To: T10 Technical Committee  
From: Rob Elliott, HP (elliott@hp.com)  
Date: 20 May 2004  
Subject: 03-240r3 SAS-1.1 Internal wide connector and cable

A 4-wide internal cable and connector solution is being designed for connecting controllers (e.g. PCI cards) to backplanes. It is intended to be used in place of 4 SATA host connectors (on the controller) to 4 separate SATA cables to 4 SATA host connectors (on the backplane). This cable/connector is being proposed for both SATA II and SAS.

**Figure 1 — 4-wide connector picture (from Amphenol)**

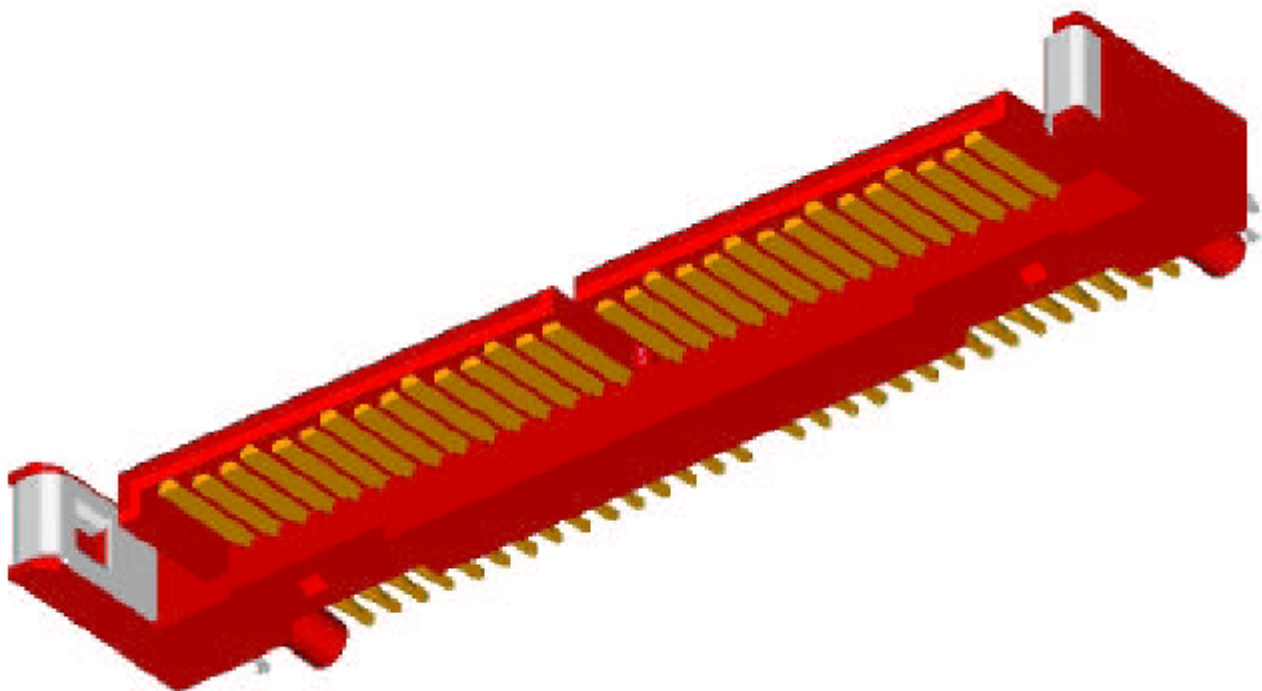
Editor's Note 1: The connector ended up with 6 sidebands rather than 4 as shown.

**Figure 2 — [SAS cables and connectors - internal wide cabled environment](#)**

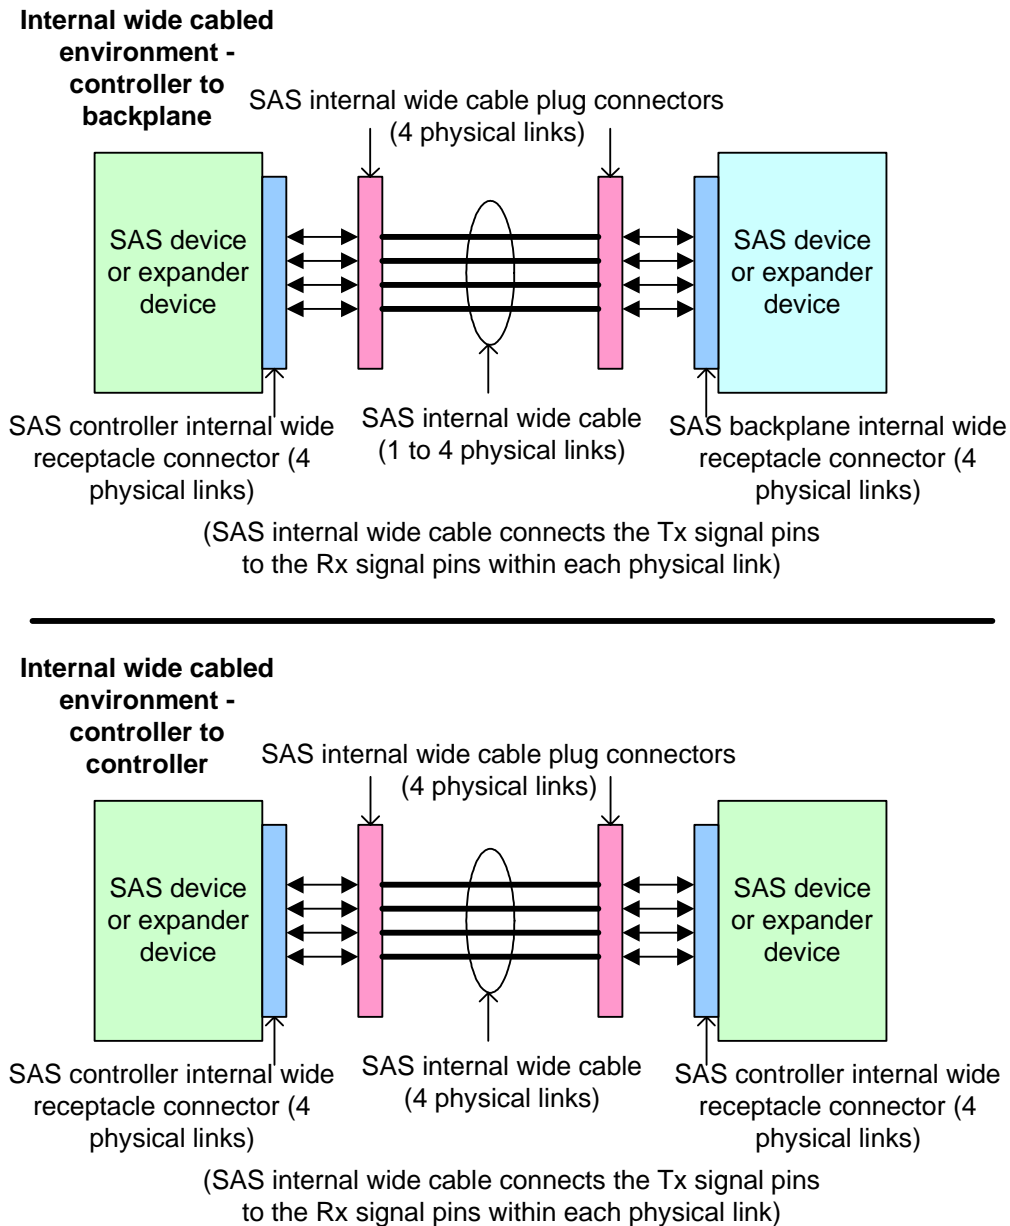
[Figure 2 shows a schematic representation of the cables and connectors defined in this standard for the internal wide environment.](#)

[The internal wide connectors have different pinouts for the controller side and the backplane side so one side's Tx signals are attached to the other side's Rx signals. Two controllers may also be attached together, provided all four physical links are used, since one side's physical link 0 is attached to the other side's physical link 3.](#)

[The internal wide connector contains 6 sideband signals which are crossed when attaching a controller to a backplane but are not crossed when attaching a controller to a controller.](#)

**Figure 3 — SAS internal wide cable attaching controller to controller**

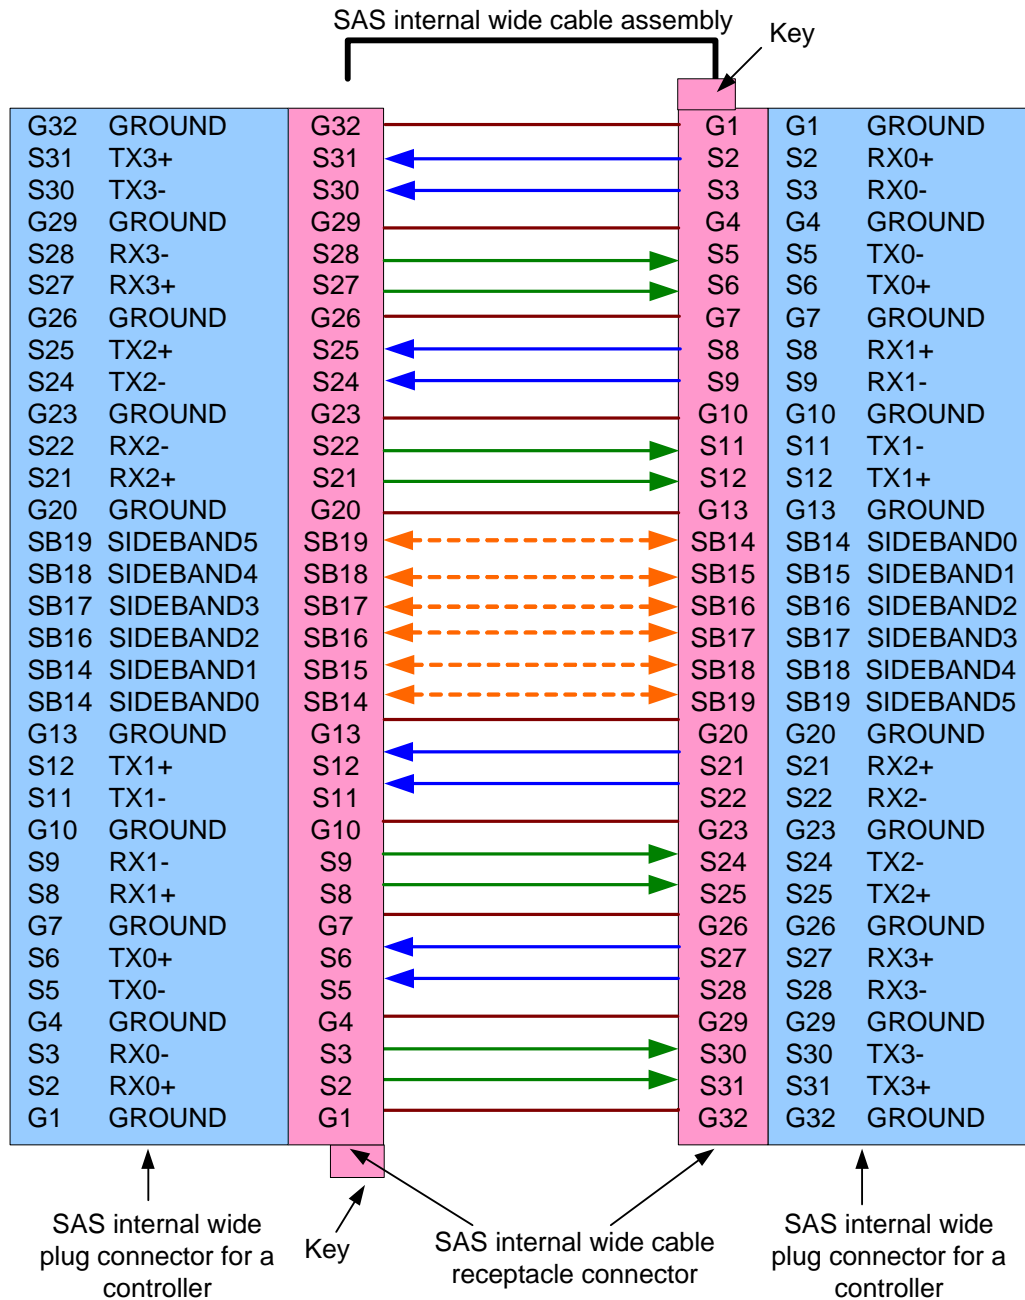
Figure 3 shows the SAS internal wide cable attaching two controllers.

NOTE 2 - For controller to controller applications, all four physical links should be used, because one side's physical link 0 is the other side's physical link 3. If both sides just used physical link 0, they would not communicate. The sideband signals are also crossed.

**Figure 4 — SAS internal wide cable attaching controller to backplane**

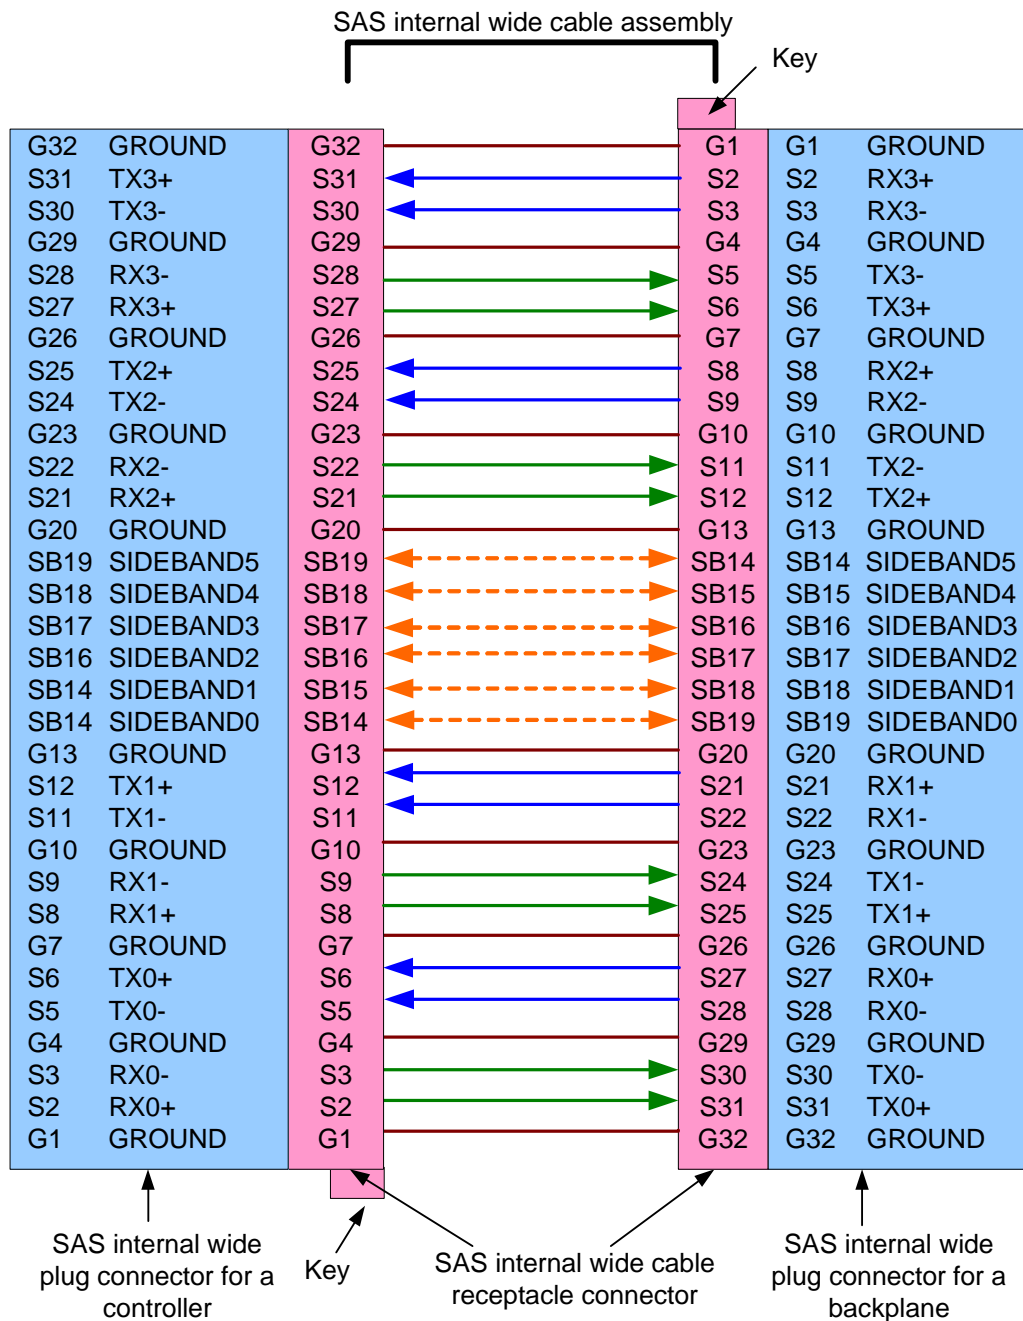
Revision 2 (28 April 2004) Changed G27 to G26 in table 999. Changed G297 to G29 in table 1000. Corrected table captions in figure 2. Fixed arrows in figure 4. Added wording options for sideband SGPIO requirements. Corrected SFF-8484 number in references and added SFF-8485.

Figure 4 shows the SAS internal wide cable being used to attach a controller to a backplane.

NOTE 3 - For controller to backplane applications, up to four physical links may be used. The sideband signals are not crossed.
